SUBJECT: COMANCHE PEAK STEAM ELECTRIC STATION (CPSES)
DOCKET NOS. 50-445 and 50-446
ADVANCE FSAR SUBMITTAL
RESPONSE TO REQUEST FOR ADDITIONAL INFORMATION ON
FSAR SECTIONS 3.7 AND 3.8

Response to Request for Additional Information,
Advance FSAR Changes to FSAR Sections 3.7, 3.8, and Q130
and
Supporting Documentation

RESPONSE TO REVIEW OF AMENDED FSAR SECTIONS 3.7 & 3.8

Figure 3.8-8

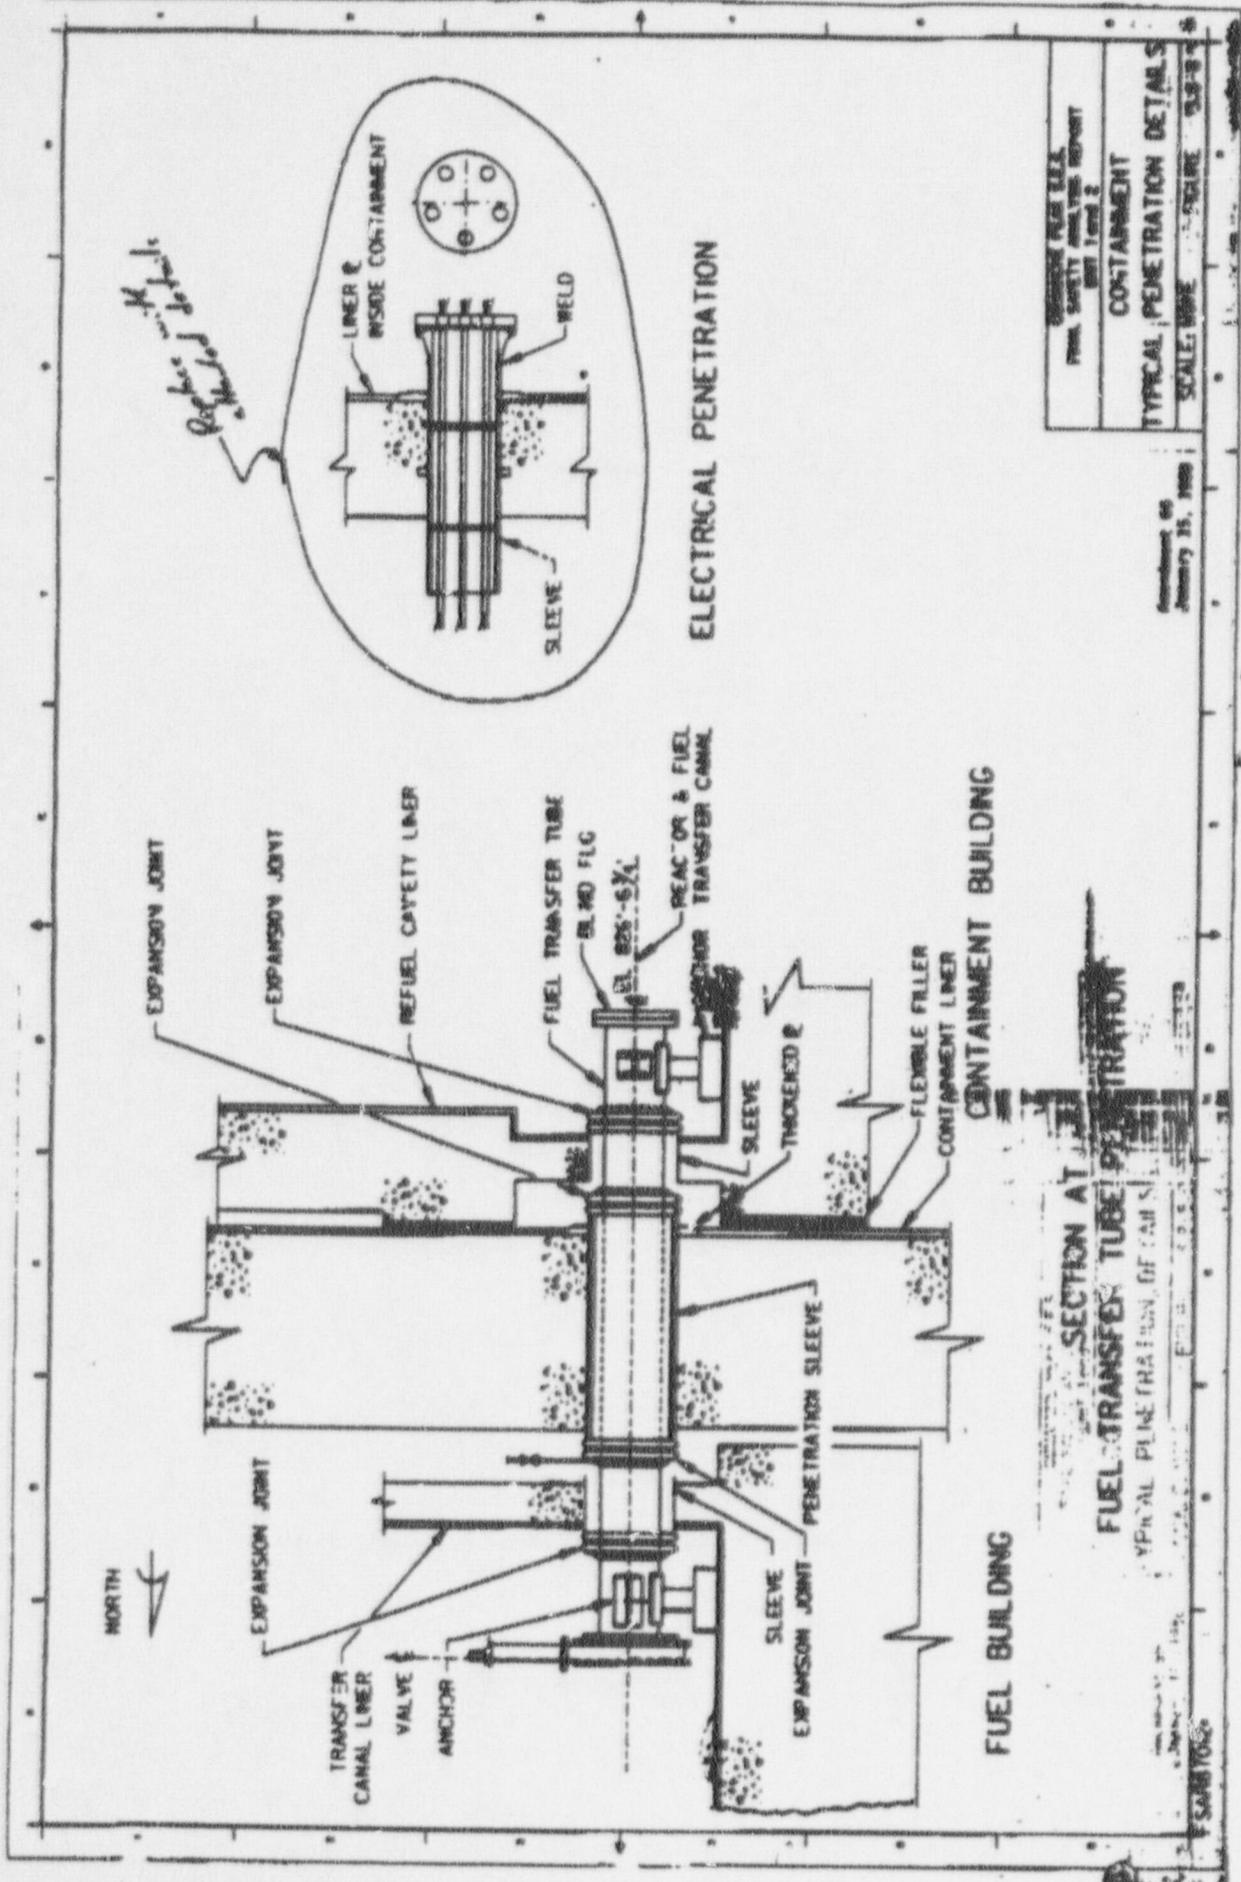
18. Provide a more descriptive detail of the electrical penetrations, e.g., o-ring, pressure monitoring, junction box, etc. identified in Figure 3.8-8.

Resp: The sketch of the electrical penetration in Figure 3.8-8 will be revised to provide detail (i.e. o-ring, pressure monitoring, and junction box).
